**AGENDA
CITY OF LAKE WORTH BEACH
HISTORIC RESOURCES PRESERVATION BOARD REGULAR MEETING
CITY HALL COMMISSION CHAMBER
WEDNESDAY, MAY 11, 2022 -- 6:00 PM**

- A. [HRPB Project Number 22-00100091: Consideration of a Certificate of Appropriateness \(COA\) for roof replacement on a building located at 623 North Ocean Breeze; PCN# 38-43-44-21-15-170-0100. The subject property is a contributing resource within the Old Lucerne Historic District and is located in the Single Family Residential \(SFR\) zoning district.](#)**

RE: **623 North Ocean Breeze**

TITLE: **HRPB Project Number 22-00100091:** Consideration of a Certificate of Appropriateness (COA) for roof replacement in a building located at 623 North Ocean Breeze; PCN# 38-43-44-21-15-170-0100. The subject property is a contributing resource within the Old Lucerne Historic District and is located in the Single Family Residential (SFR) zoning district. The future land use designation is Single Family Residential (SFR).

Exhibit A: Existing and Proposed Roofing Systems

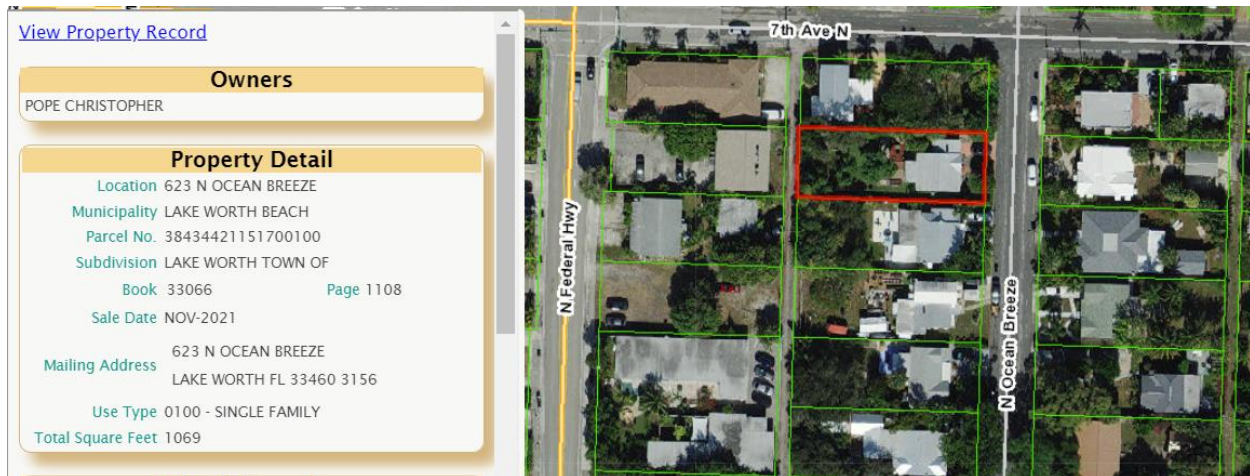
Staff Analysis: The roof replacement is depicted exhibit A, above. Based on the existing original roof and the City's Historic Preservation Design Guidelines, staff contends that the proposed standing seam metal panel roofing system is not an appropriate replacement for the original metal shingle roofing system.

Staff Analysis: Based on the existing original roof and the City's Historic Preservation Design Guidelines, staff contends that the proposed standing seam metal panel roofing system is *not a successful replacement* for metal shingles. However, it should be noted that there limited available product options that also meet Florida Building Code Requirements. Further, the existing product options are similar, but to not exactly replicate the existing roof material.

Staff Analysis: Yes, in this case the original character of the building associated with the roof's appearance would be destroyed by the removal and replacement of the original metal shingle with a standing seam metal panel roofing system.

STAFF RECOMMENDATION: Many of the City’s Frame Vernacular and Frame Minimal Traditional buildings originally utilized a metal shingle. However, few examples of these original metal shingle roofs remain on our historic structures. As there are few remaining examples, **staff is recommending that the proposed roof be maintained or replaced with in-kind products.** However, it should be noted that there are limited replacement options for metal shingle products that also meeting Florida Building Code Requirements. These products include the Victorian shingle by Berridge Manufacturing Co. and the Oxford shingle by Classic Metal Roofing, which provide for a similar, but not identical appearance to the historic metal shingles. Therefore, **staff is also requesting guidance on the appropriateness of alternate materials for future applicants.**
